City of Edmonton First Place Program Twin Brooks Community Design Engagement Design Engagement Meet #1

Meeting Date: April 20th, 2017, 6:00 pm - 8:15 pm

On the evening of April 20, 2017, community residents, City and Landmark Homes staff met to continue Twin Brooks First Place community design engagement process.

Figure 1: Aerial view of zoning map

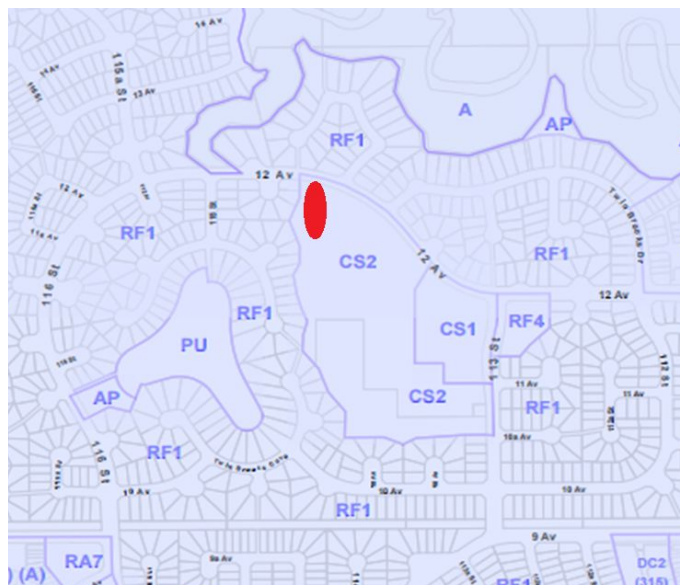
- Builder explained zoning requirements construction must follow (eg permitted use, setbacks, density, building height, site coverage maximum and private amenity space, separation space and parking requirements.
- Discussion of how building height is determined and separation from existing homes discussed.

Figure 2: Drive Under Townhome

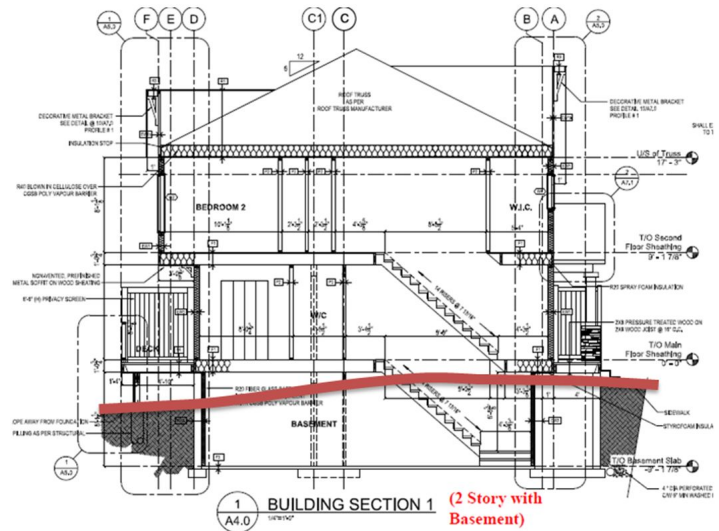
- Cross section details of homes with surface parking and drive under presented and shared.
- Pros and cons of each design discussed.
- Residents reflect preference for the drive under townhomes design.

Figure 7: Layout Option#4

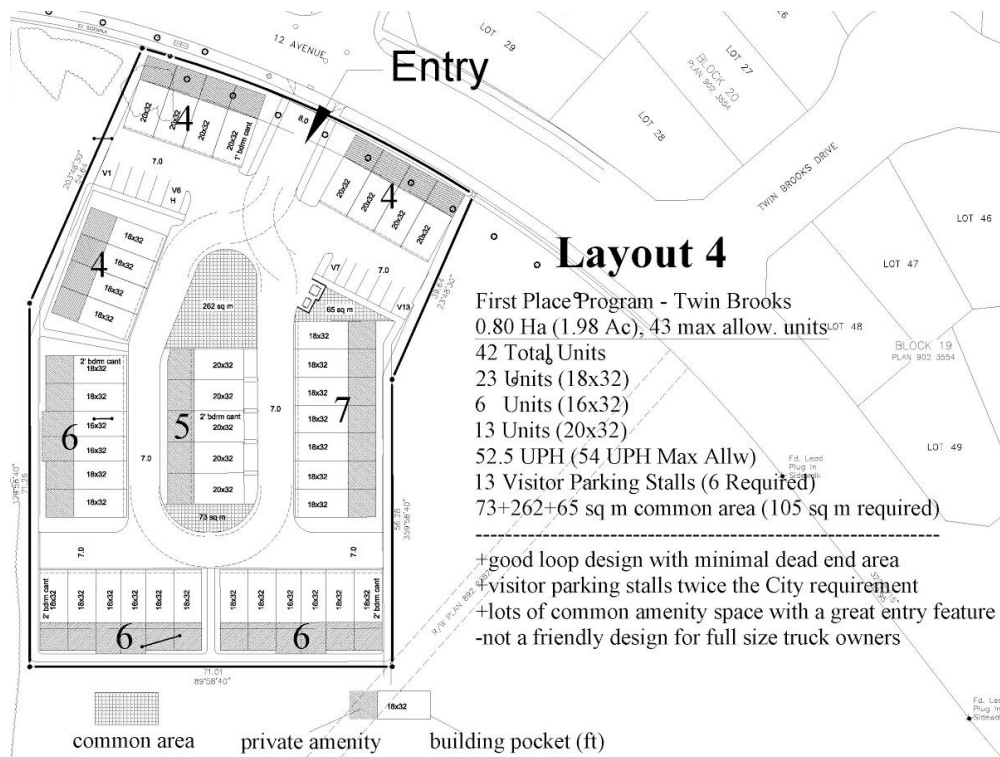
- Based on preferences and comments design participants provided at the March 21st design meeting, Builder developed four different site layouts for design.
- Each layout was presented separately and details explained by the builder.
- Design participants asked builder Questions and discussion followed for each of the four designs.
- Design participants expressed a preference for layout option **Four** as it closely matches first meeting preferences ;
 - it offers the most resident and visitor parking,
 - all of the homes are Drive under,
 - the private amenity area is centrally located is visible from 12th Ave.,
 - this option offers the most homes with three bedrooms.
- Design participants also asked builder to be mindful of light from community rinks effect on the homes facing east and ask for adjustments to option four design at southwest corner due to proximity to existing homes.

7. Safety concern on south west corner buffer zone from First Place developments to adjacent single family lots

- Builder will revise option four and present any revisions at next meeting.
- City will request a development officer attend to review the revised layout and confirm it follows building site zoning requirements.
- In addition, at next meeting builder will present detailed exterior design information for review, and bring details of the site safety plan.
- April meeting notes will be shared with design participants within a week before they are posted online.

We have mentioned this to our building architect and landscape architect. They will visit the site and find a solution that is going to provide privacy buffer for adjacent single family units and being safe for kids as well. Possible solutions will be presented at next meeting.
